# SAN FRANCISCO PLANNING DEPARTMENT

## Supplemental Service Variants for the Transit Effectiveness Project EIR Memorandum to the San Francisco Planning Commission

*Date:* March 13, 2014  
*Case No.:* **2011.0558E**  
*Project Title:* **Transit Effectiveness Project (TEP)**  
*Zoning:* Citywide – N/A  
*Block/Lot:* Citywide – N/A  
*Lot Size:* Citywide – N/A  
*Project Sponsor:* San Francisco Municipal Transit Agency (SFMTA)  
Sean Kennedy, Program Manager, TEP  
*Lead Agency:* San Francisco Planning Department  
*Staff Contact:* Debra Dwyer – (415) 575-9031  
Debra.Dwyer@sfgov.org

## Line 8X - Bayshore Express (Revised)

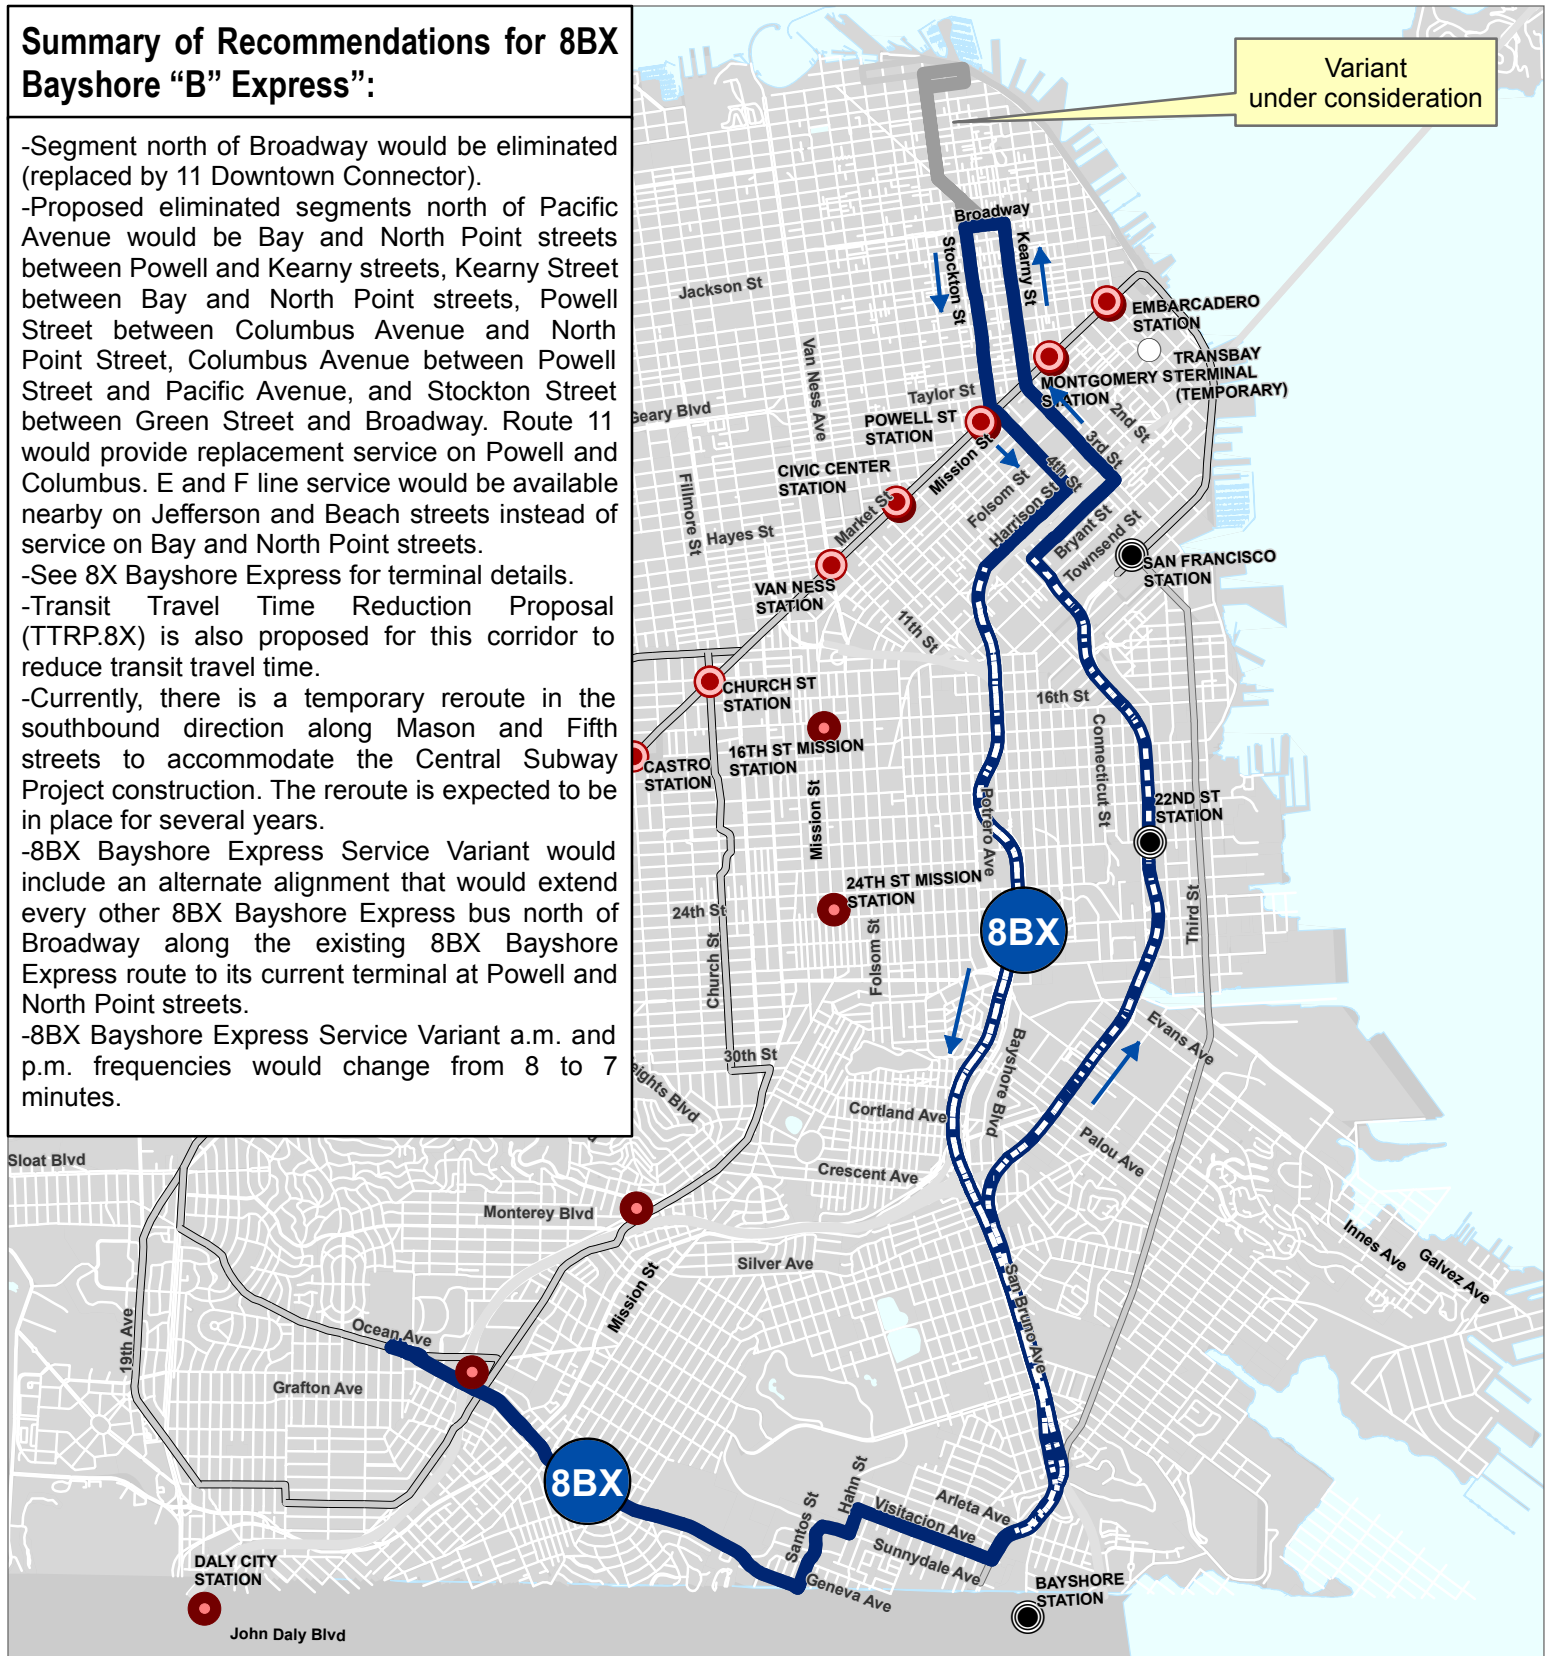
This supplemental service variant would provide service on a limited basis along the 8X Bayshore Express route segment north of Broadway, which is proposed to be eliminated under the 8X Bayshore Express Service Improvements with service replaced by the new 11 Downtown Connector. This variant would extend every other 8X Bayshore Express bus to the current terminal at Powell and North Point streets, rather than ending all service at Broadway. Under this Variant, the 8X Bayshore Express would increase midday service frequency from 9 minutes to 7.5 minutes. This variant is essentially maintaining existing conditions north of Broadway except as it relates to frequency. Please see the Service Variant shown on the revised 8X Bayshore Express Service Improvement map.

## Line 8BX - Bayshore "B" Express (Revised) Recommended Route Alignment

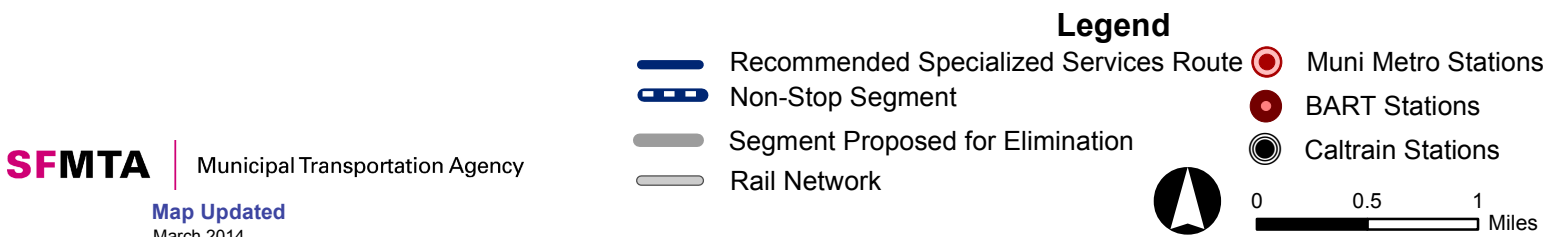
This supplemental service variant would provide service on a limited basis along the 8BX Bayshore Express route segment north of Broadway, which is proposed to be eliminated under the 8BX Bayshore Express Service Improvements with service replaced by the new 11 Downtown Connector. This variant would extend every other 8BX Bayshore Express bus to the current terminal at Powell and North Point streets, rather than ending all service at Broadway. Under this Variant, the 8BX Bayshore Express would increase the a.m. and p.m. peak period service frequency from 8 minutes to 7 minutes in the a.m. peak and 7.5 minutes to 7 minutes in the p.m. peak. This variant is essentially maintaining existing conditions north of Broadway except as it relates to frequency. Please see the Service Variant shown on the revised 8BX Bayshore Express Service Improvement map.

- 8BX Bayshore Express Service Variant a.m. and p.m. frequencies would change from 8 to 7 minutes.

## Line 17 - Park Merced (Revised) Recommended Route Alignment

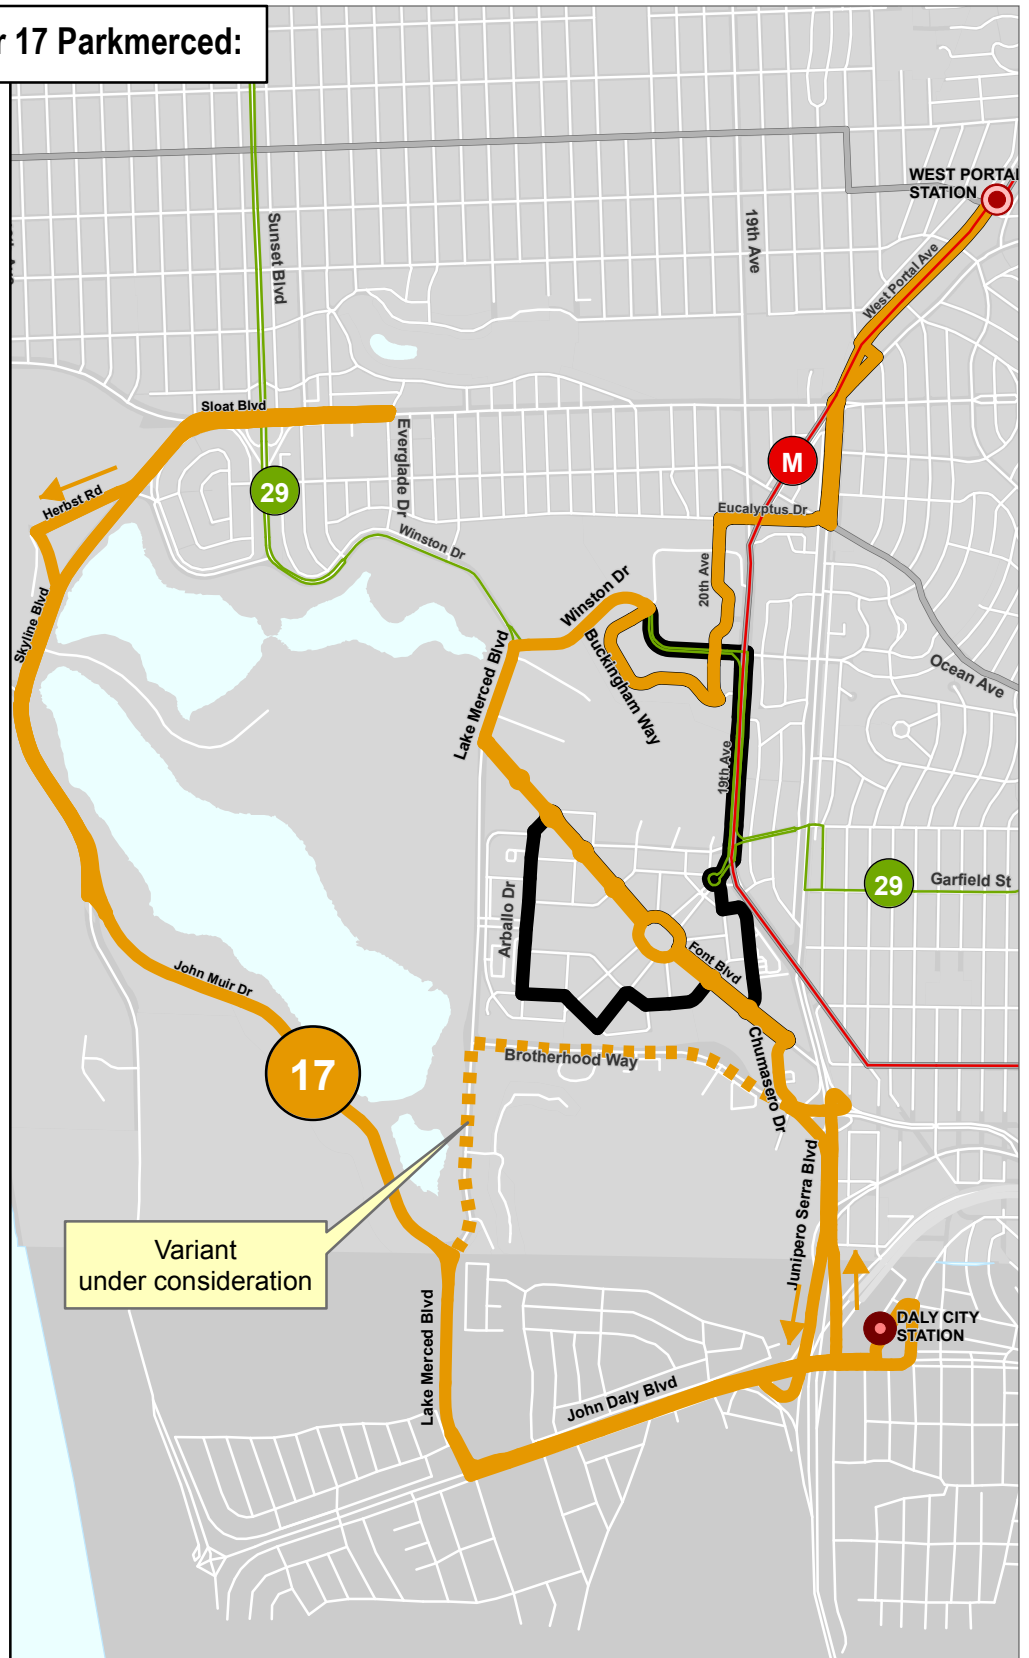
The 17 Parkmerced Supplemental Service Variant new transit street segments not currently served by any Muni route would be Font Boulevard between Lake Merced Boulevard and Arballo Drive, Chumasero Drive between Font Boulevard and Brotherhood Way, and Brotherhood Way between Junipero Serra and Lake Merced boulevards. Please see the Service Variant shown on the revised 17 Parkmerced Service Improvement map.

### Line 33 - Stanyan (Revised) Recommended Route Alignment

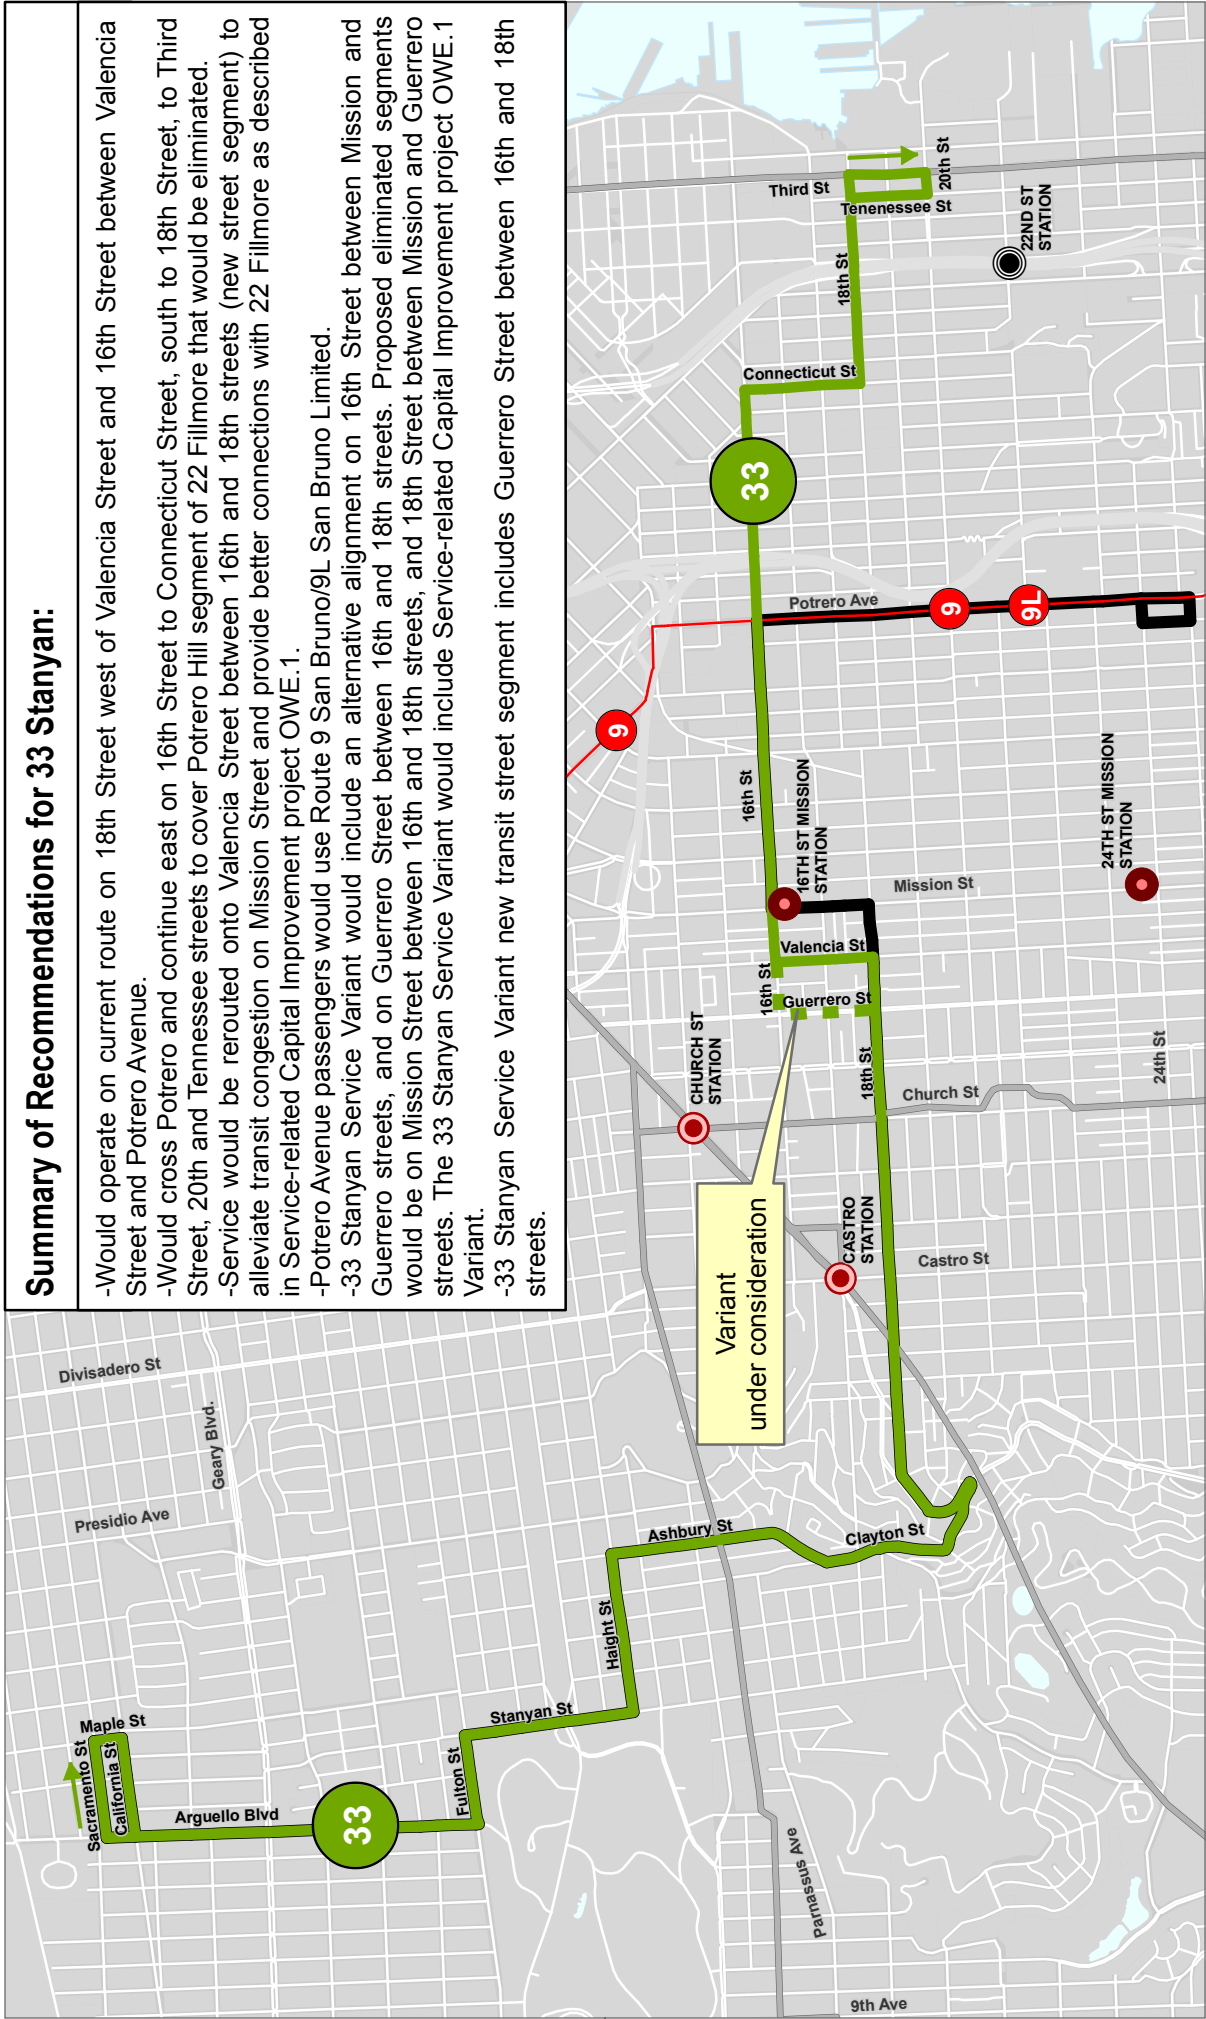
The 33 Stanyan Supplemental Service Variant new transit street segment not currently served by any Muni route would be Guerrero Street between 16<sup>th</sup> and 18<sup>th</sup> streets. Please see the Service Variant shown on the revised 33 Stanyan Service Improvement map.

- Service would be rerouted onto Valencia Street between 16th and 18th streets (new street segment) to alleviate transit congestion on Mission Street and provide better connections with 22 Fillmore as described in Service-related Capital Improvement project OWE.1.
